# Access Compliance Report

## Public Rights-of-Way

### (Curb Ramps)

Intersection ID: N/A	Main Street: NATIONAL_AV	Cross Street: POTOMAC_RIVER_PY	Location: S
ADA ID: C6130A5E00C2	Ramp Type: Directional1	Initial Pass/Fail: Fail	Overall Compliance: No
Severity Score: 13.75			
Codes/Mitigation Info/Possible Solution		Field Measurements/Component Compliance

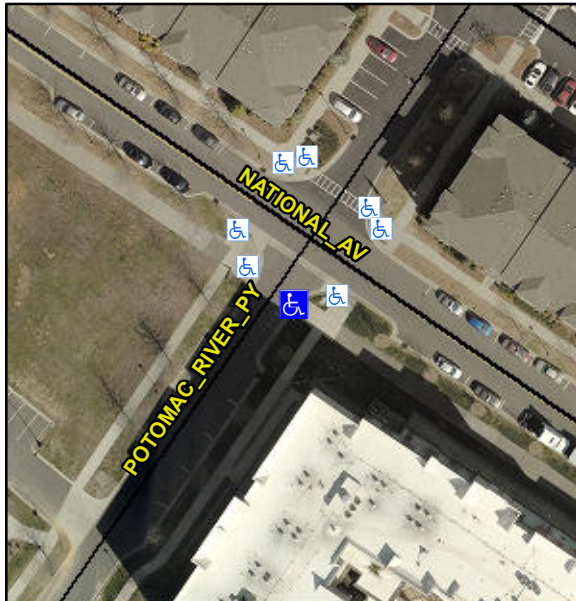
**R304.2.2, R304.5.3**

Compliance	Description	Data	Compliance	Description	Data
N/A	Ramp Length (in)	137.0	N/A	Grade Break?	N/A
Yes	Ramp Width (in)	58.0	N/A	Grade Break Slope (%)	0.0
No	Ramp Slope (%)	8.8	N/A	Grade Break XSlope (%)	0.0
No	Ramp XSlope (%)	3.7			
N/A	Flare Type LT	N/A	N/A	Flare Type RT	N/A
N/A	Flare Slope LT (%)	N/A	N/A	Flare Slope RT (%)	0.0
N/A	Flare Traversable LT?	N/A	N/A	Flare Traversable RT?	N/A
N/A	Landing Length (in)	0.0	N/A	DWS Provided?	N/A
N/A	Landing Width (in)	0.0	N/A	DWS Contrast?	N/A
N/A	Landing Slope (%)	0.0	N/A	DWS Length (in)	N/A
N/A	Landing X Slope (%)	0.0	N/A	DWS Full Width?	N/A
N/A	Landing Curb? (Y/N)	N/A	N/A	DWS Offset LT (in)	N/A
N/A	Shared Landing?	N/A	N/A	DWS Offset RT (in)	N/A
N/A	Gutter Ponding?	0.0	N/A	Gutter Slope (%)	N/A
N/A	Gutter Lip Ht (in)	0.0	N/A	Gutter X Slope (%)	N/A
N/A	Painted X Walk1?	No		Road Slope (%)	2.2
	X Walk 1 Direction	To W		Road X Slope (%)	0.2
	X Walk 1 Width (in)	N/A		Clear Space?	N/A

**Remove & Replace Entire Ramp.**
